LAND EAST AND WEST OF HYDE END ROAD, SHINFIELD
DESIGNER'S RESPONSE

BLOOR HOMES (SOUTHERN) AND THE UNIVERSITY OF READING
11 February 2026

Prepared by:	E Hine
Authorised by:	A Golding
Date:	11 February 2026
Document Reference:	HD068 – R016

Road Safety Audit – Hyde End Road, Shinfield, On-Site and Access Proposals

Appendix B – General Arrangement Drawing HD068-FA-001/D

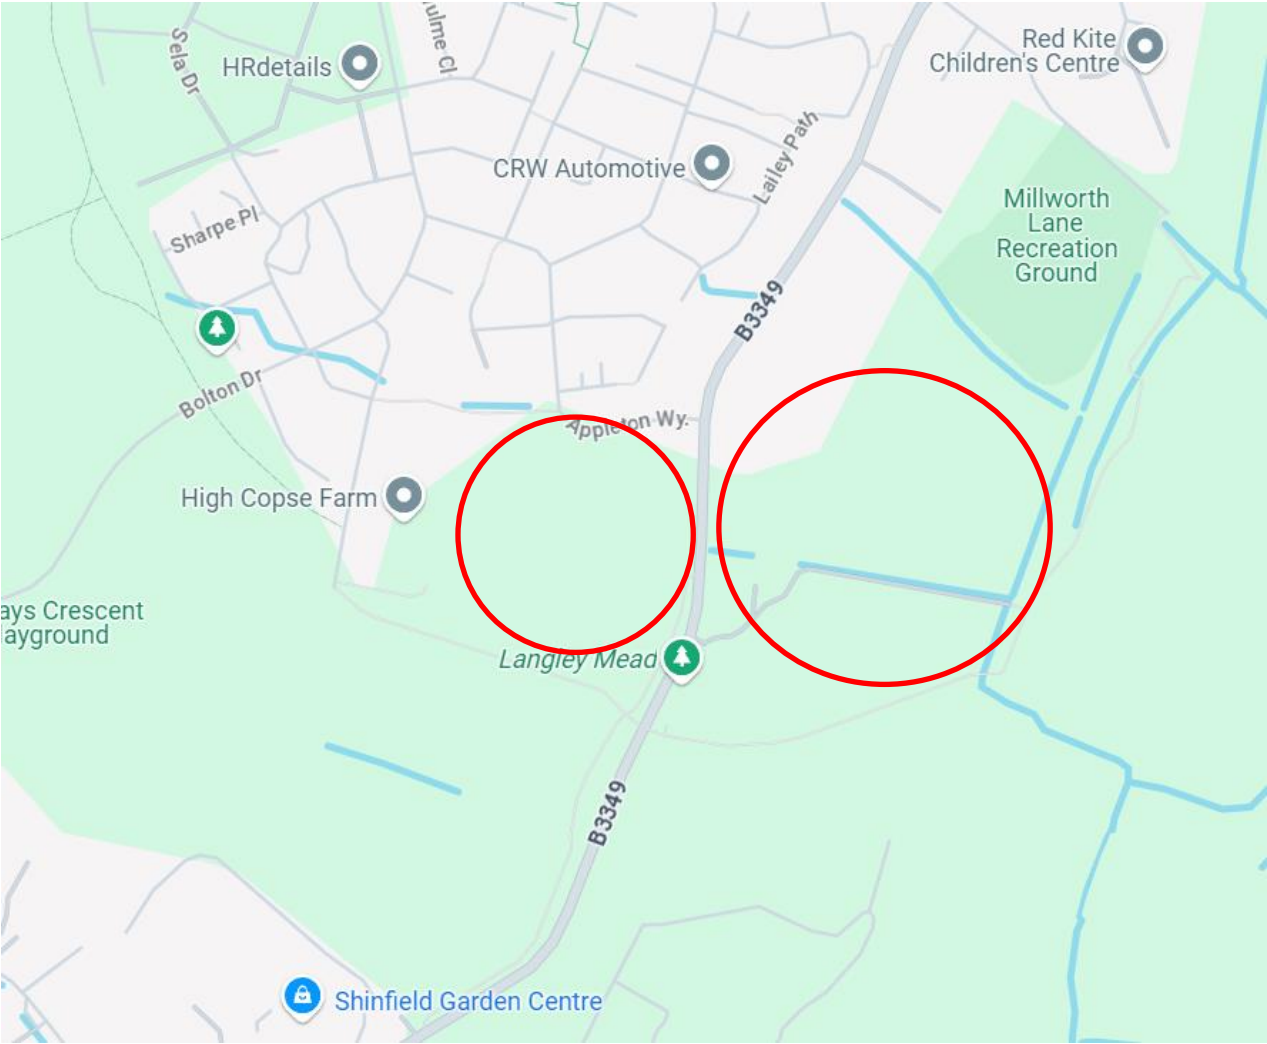
Many of the shared surfaces within the drawings supplied have what looks to be a footway alongside the road or around parking areas. It is unclear if these areas will be flush without an upstand which could cause pedestrians to slip or trip.

- 2.2.3 Ensure that shared surfaces are flush without upstand kerbs.

- 2.5.3 The footways at these locations end abruptly, directing pedestrians into the main carriageway where they will be at risk of being struck by passing vehicles

- 2.5.4 Provide a crossing point to join the opposite footway with dropped kerbs and tactile paving.

The footways either side of this road appear to be discontinued where the road crosses the green space. Pedestrians may walk in the carriageway as a consequence, where they will be at risk of being struck by passing vehicles

- 2.6.3 Provide continuous footways on both sides of the road

Very few informal pedestrian crossing points, with dropped kerbs and tactile paving, have been indicated within the development. Pedestrians will wish to cross side roads, cross the 'spine' roads at various locations, and also cross where footways terminate (see 2.5 above)

- 2.7.3 Provide pedestrian dropped kerbs and tactile paving where appropriate

- 2.2.4 *Agreed - As depicted at the General Arrangement Drawing HD068-FA-001/D at **Appendix B**, a number of streets are proposed as shared surface streets with block paving and planted margins where pedestrians will be accommodated within the block paved areas. Where margins are included, such as around parking bays, then these are to be provided flush without upstand kerbs to prevent slips or trips.*

- 2.5.5 *Agreed – As depicted at General Arrangement Drawing HD068-FA-001/D at **Appendix B**, crossing points with dropped kerbs and tactile paving are proposed at the two locations where footways are proposed. The third location at plot 172 is a shared surface street, so a separate tactile paving crossing is not required.*

- 2.6.4 *As depicted at the General Arrangement Drawing HD068-FA-001/D at **Appendix B**, this is proposed as a shared surface street, with planted margins so footways are not proposed. A shared surface street is proposed in accordance with Wokingham Borough Council's Living Streets design guide which allows a maximum of 50 units to be served via such a street.*

- 2.7.4 *Agreed – General Arrangement Drawing HD068-FA-001/D at **Appendix B** does include new tactile crossings, but additional tactile crossings will be considered and included at the bellmouths of side roads as the detailed design of the scheme progresses.*
